## Code Technologies Committee Report Elevator Lobby – Group A changes:

Following are code change proposals submitted through CTC from Elevator Lobby study group and related changes.

### Elevator Lobby

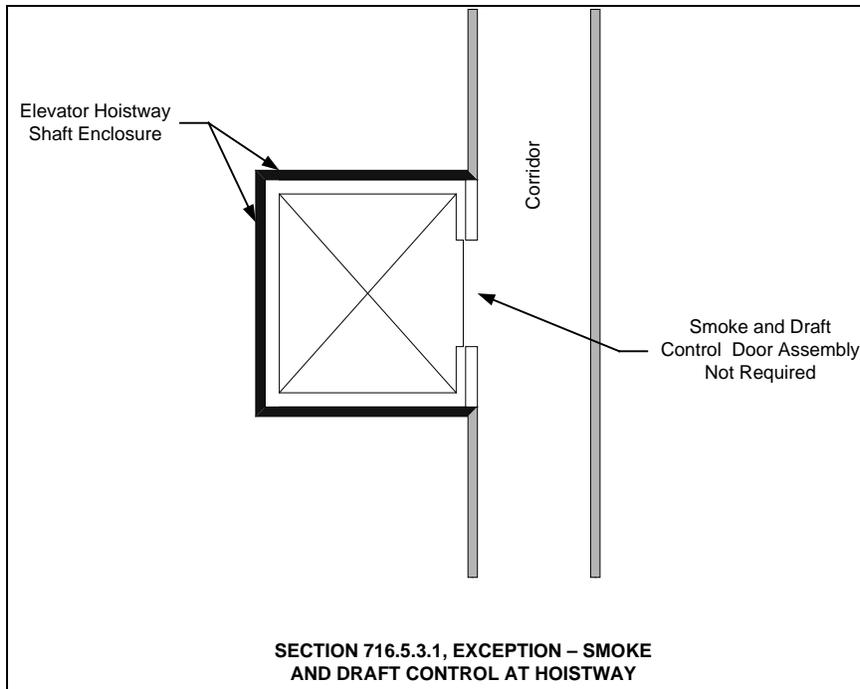
This proposal is intended to clarify that when an enclosed elevator lobby is not required in accordance with Section 713.14.1 that smoke and draft protection is not required when the hoistway opens into a rated corridor. See figure below. Section 713.14.1 is based upon number of stories and not the fact that such elevators open onto a rated corridor so it is not entirely clear how the code is currently written that this was the intent. The following are the sections that are relevant to this issue and which demonstrate how such confusion could occur. The lobby provisions are independent from the corridor provisions.

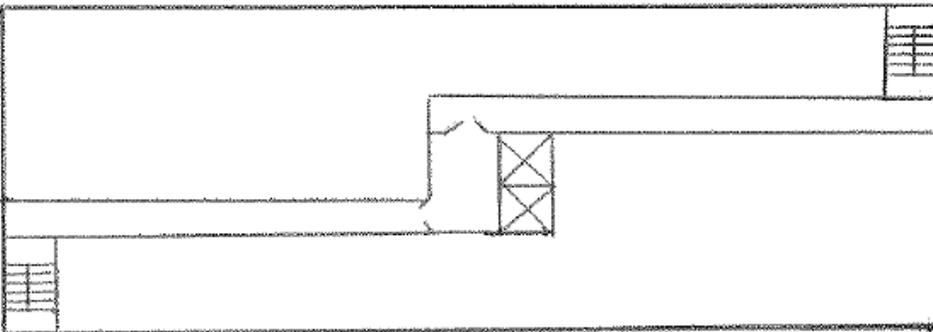
1. Corridor passes through passenger elevator lobby. If provided with access to a stair and proper construction, could this be a Fire Service Access Elevator Lobby and/or an Occupant Evacuation Elevator Lobby?

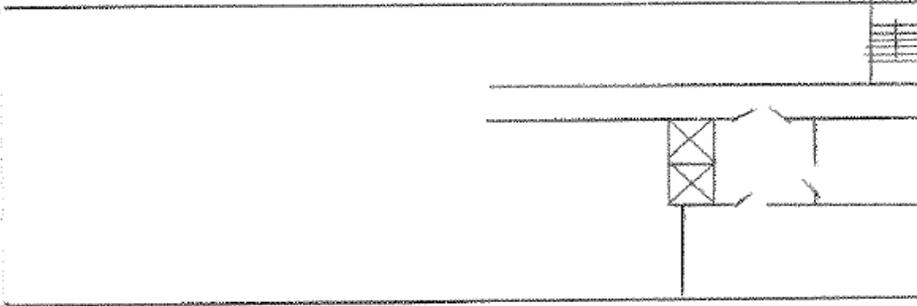
2. Rooms connect to and exit through elevator lobby. If provided with access to a stair and correct construction, could this be a Fire Service Access Elevator Lobby and/or an Occupant Evacuation Elevator Lobby?

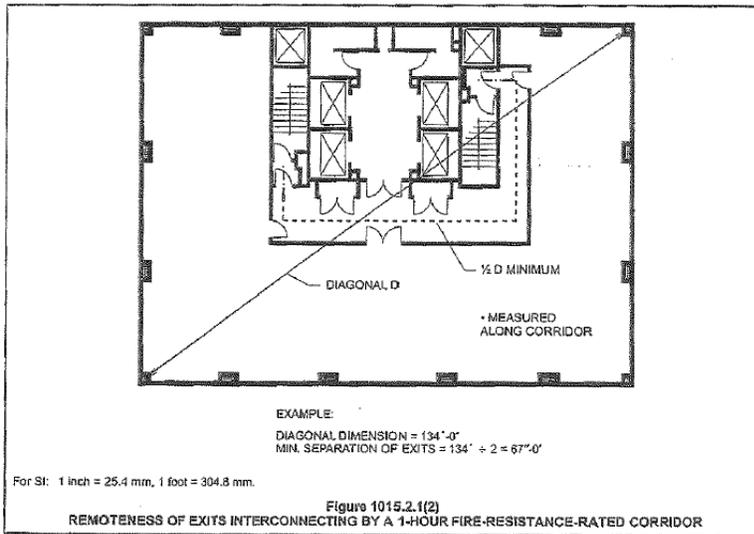
Even the commentary has an example of what appear to be restrooms off an elevator lobby as follows:

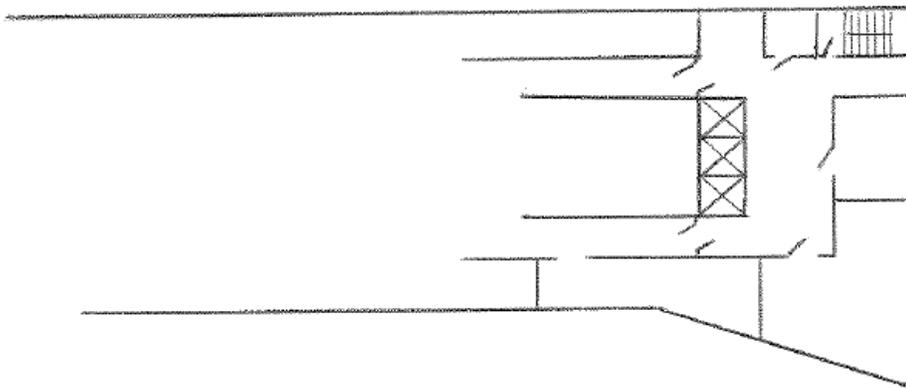
3. The following is an example of corridors passing through a lobby, along with rooms with direct connection to lobby, serving as passenger elevator lobby Fire Service Access lobby and/or Occupant Evacuation Elevator lobby. This is an actual design submitted for review.
